SERVICE INFORMATION BULLETIN

APPLICABILITY: 2013MY Legacy and Outback
 2014-20MY Forester
 2012-20MY Impreza
 2013-20MY Crosstrek
 2015-20MY WRX
 2016-20MY BRZ
 2019MY Ascent

NUMBER: 07-169-20

SUBJECT: Push Button Start Switch- Label Change

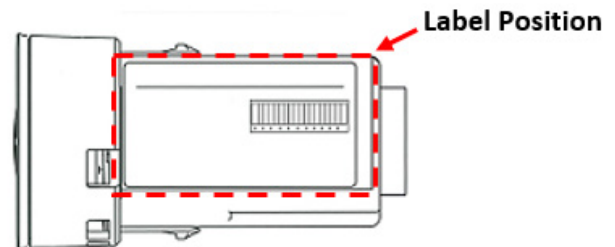
This Service Information bulletin describes a change made to the labels applied to the push to start switches used on the models listed above. There has been NO change made to the operation or functionality of the switches. The label change was made for compliance reasons in the Indonesia, Argentina and China markets.

The part number switches listed below include the new labels. Any changes identified between the OLD and NEW part labels can be disregarded.
